Planning Commission

Wednesday, April 8, 2020 – 7:00 p.m.

RE: **CALIBER COLLISION AT 566 N. WALL AVE.
Site Plan Review**

The Site is located at approximately 566 North Wall Avenue in between Wall Avenue and North Harrisville Road (Hwy 89). The Developer is proposing to combine 5 parcels into a 2-lot commercial subdivision. They have also submitted a site plans to develop Lot 1 of the subdivision. We have completed a review of the site plan and have the following comments:

CALIBER COLLISION
566 N. WALL AVE.
HARRISVILLE, UT 84404
STORM WATER PL

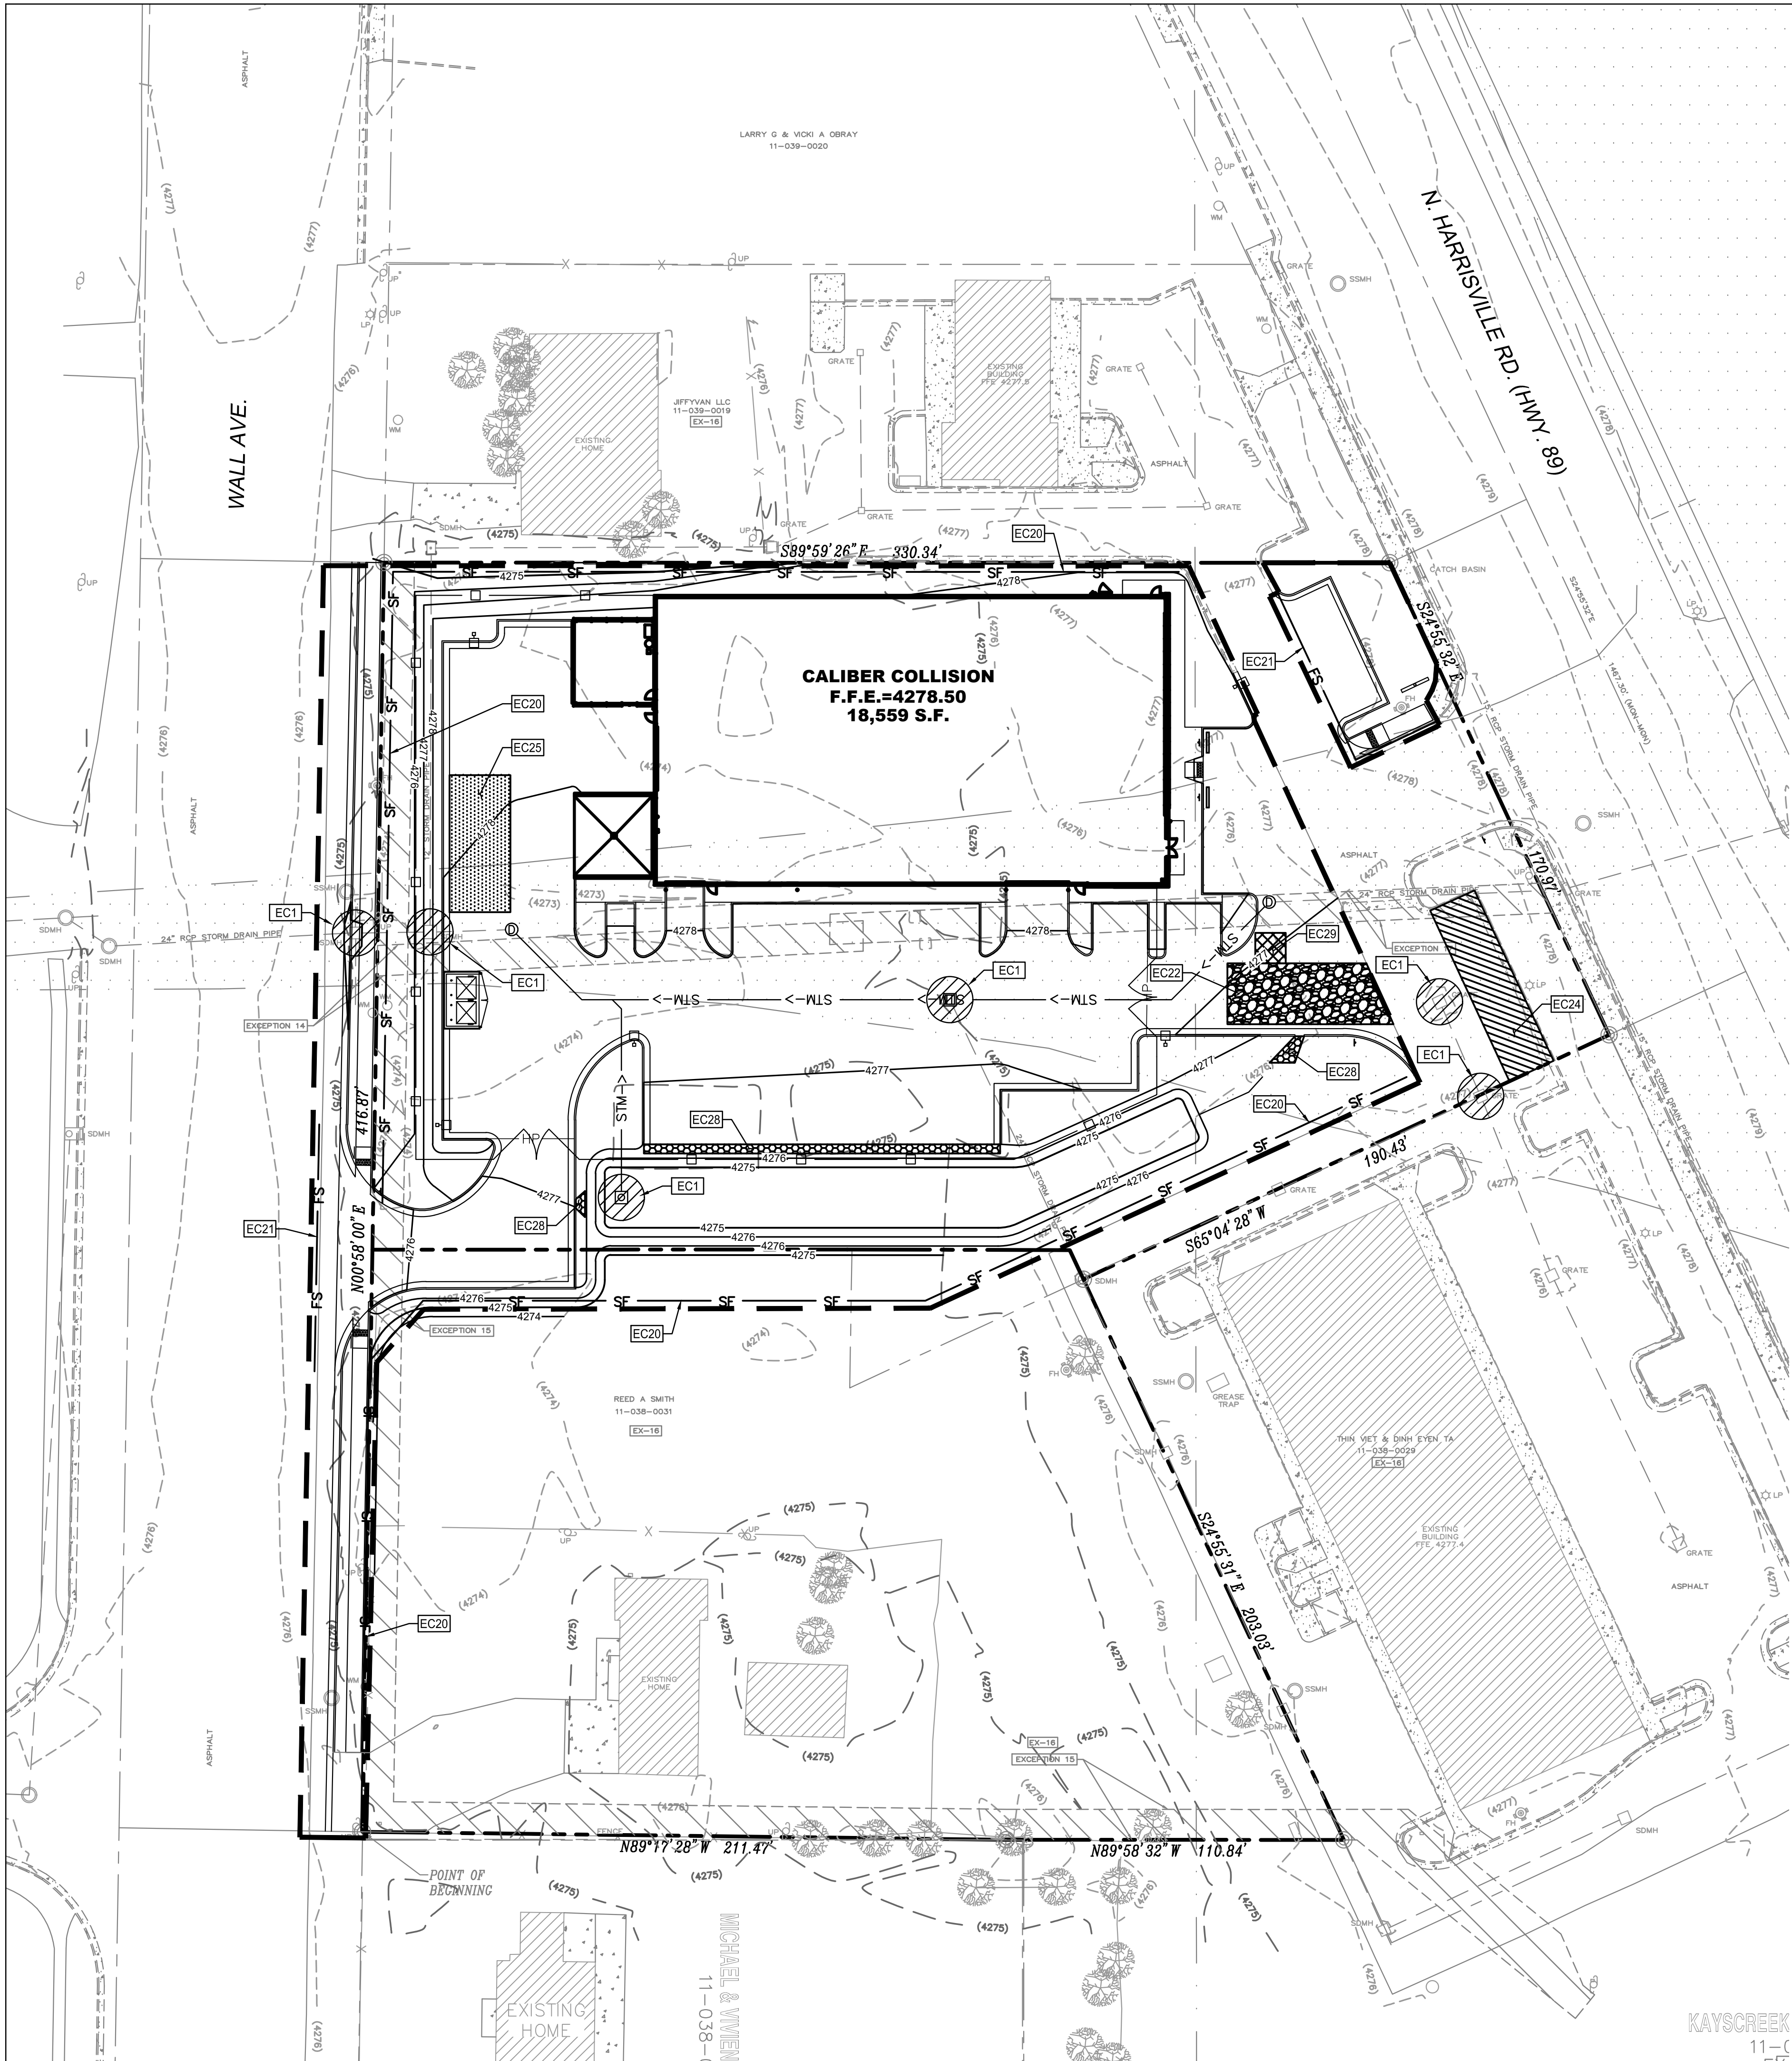
10. Tie-in the 12" line from the detention area to a manhole.
11. Include a detail for the detention basin outlet structure in the plans. This structure should show the orifice size and configuration and have an overflow at the high water mark.

12. Ensure that the drainage box identified as ST36 on the plans has a solid manhole lid so that it is clear that it is not a low spot and will not allow surface runoff to enter the box.

SHEET NO.
C-501

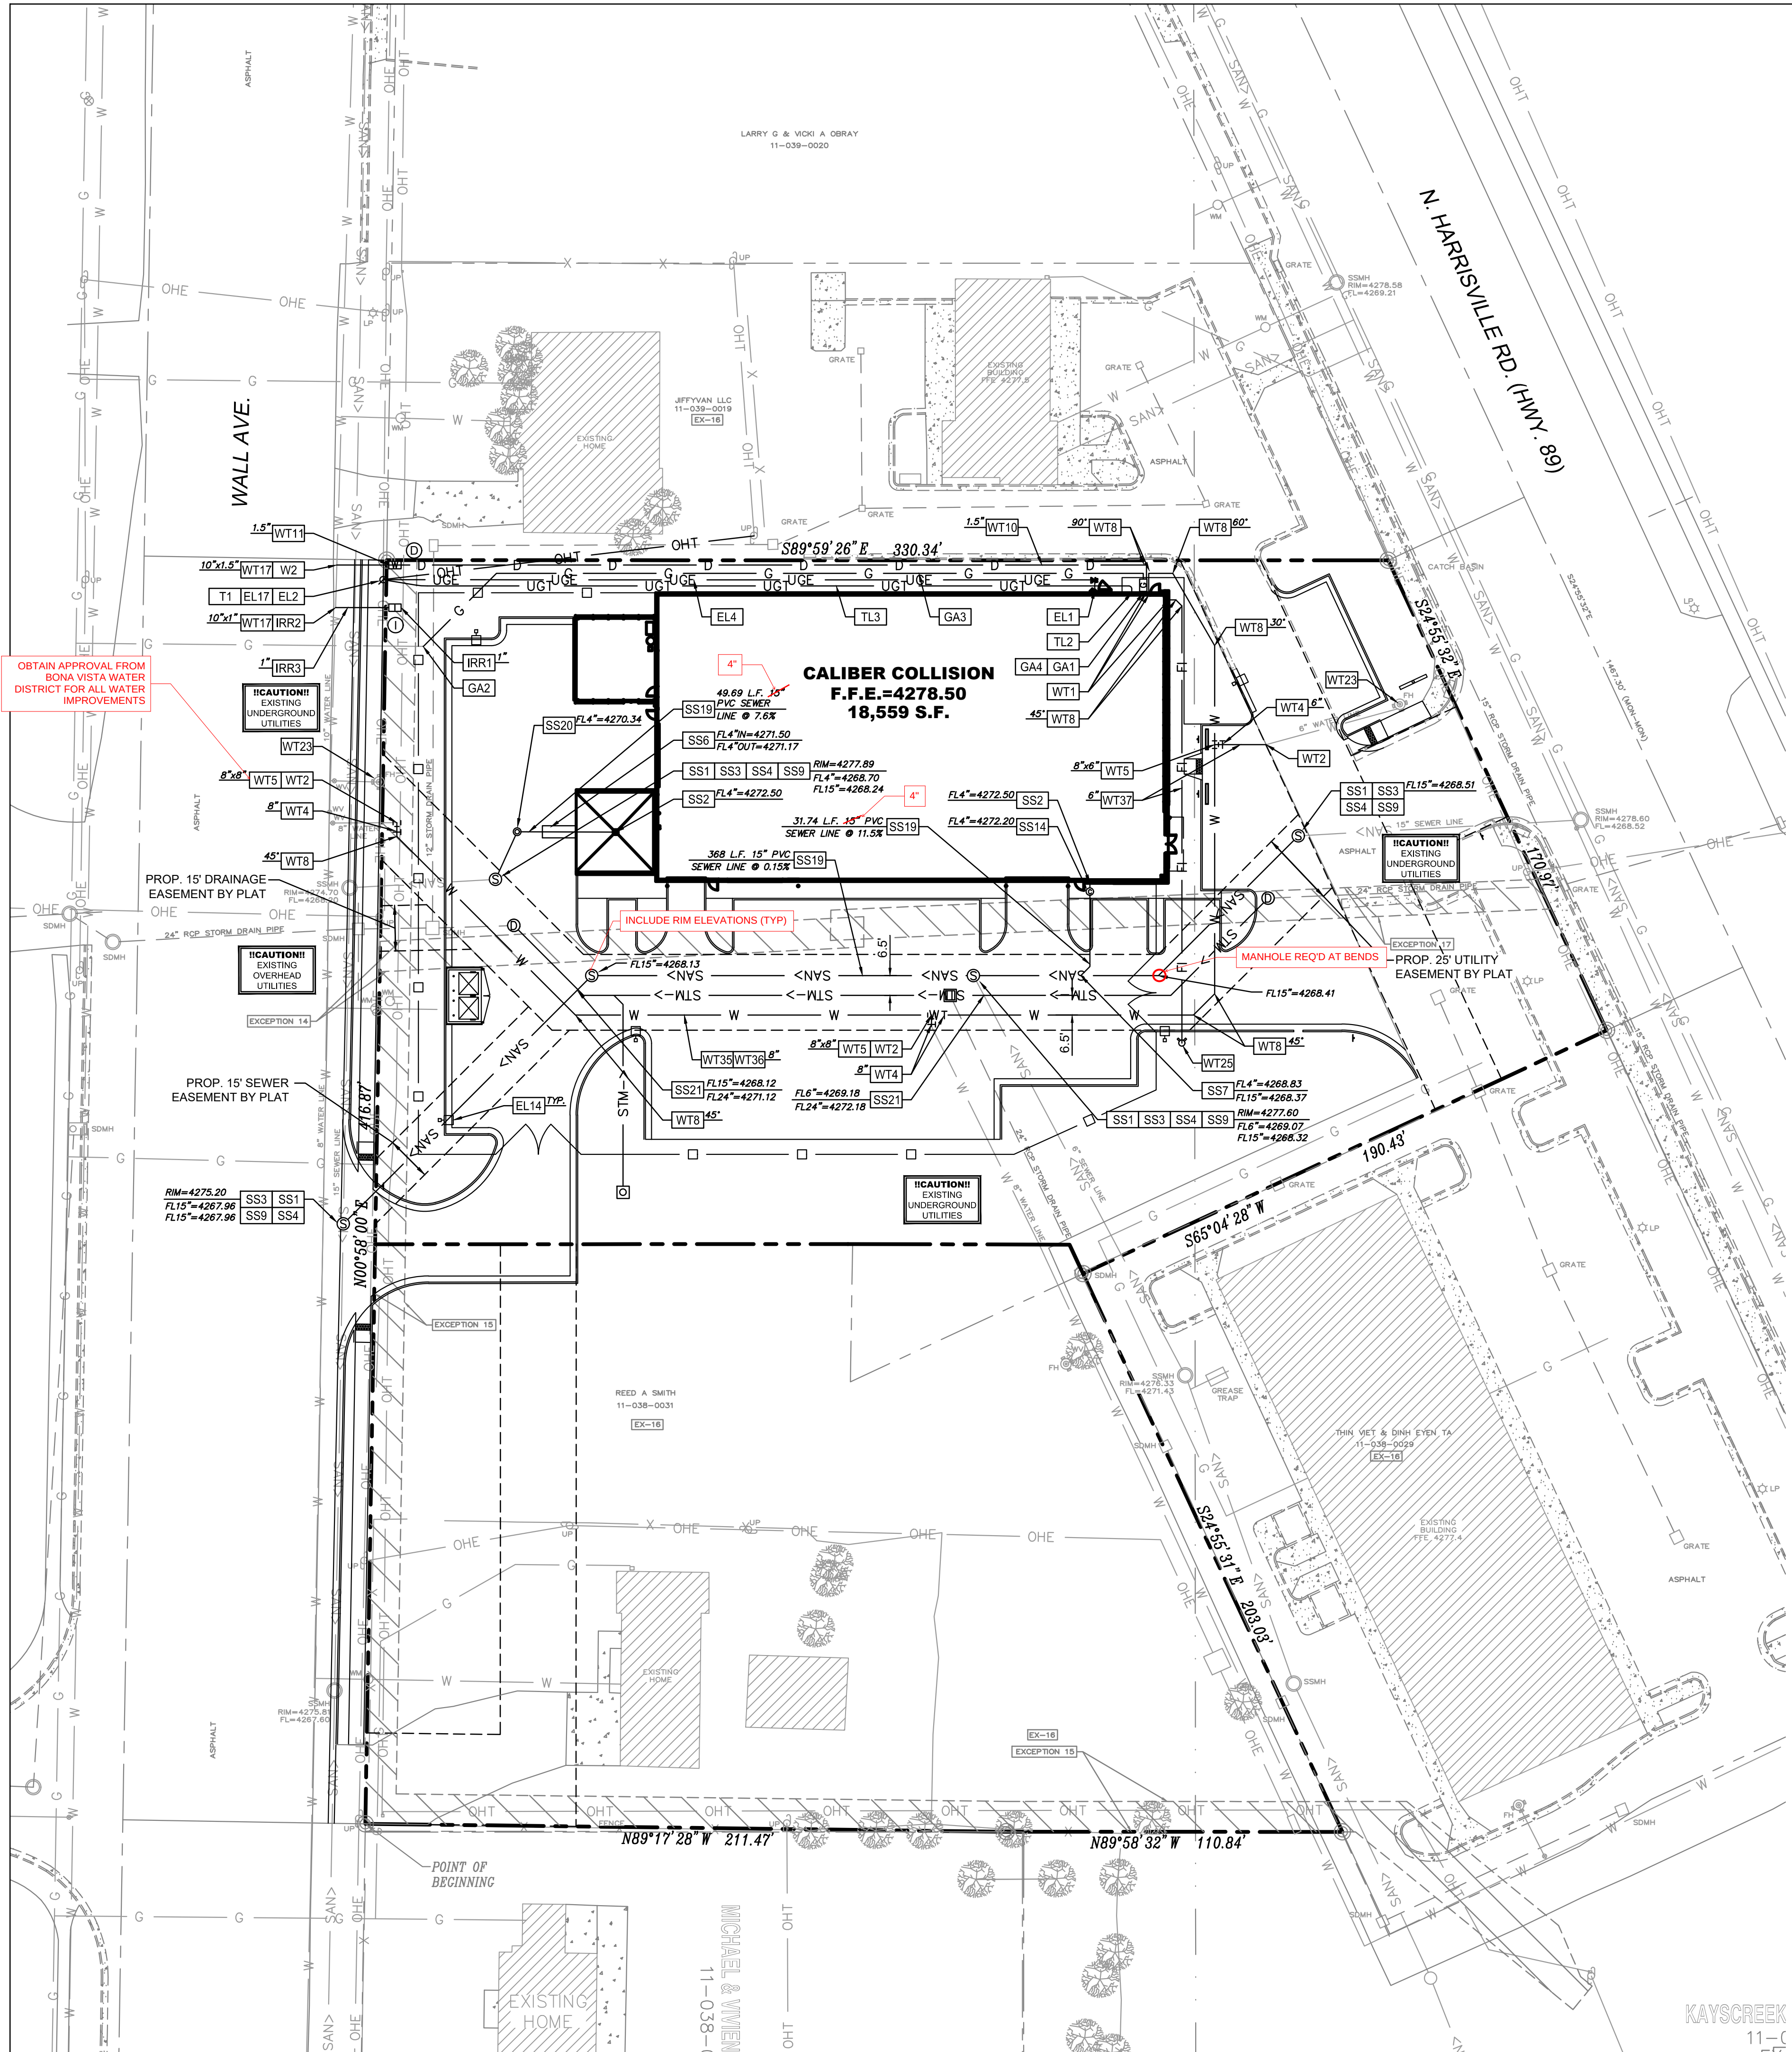
8. Revise parking stall configuration as needed. The stalls next to the detention basin aren't accessible due to the adjacent stalls.
9. A manhole is required at any bends on the storm drain or sanitary sewer pipe alignments.
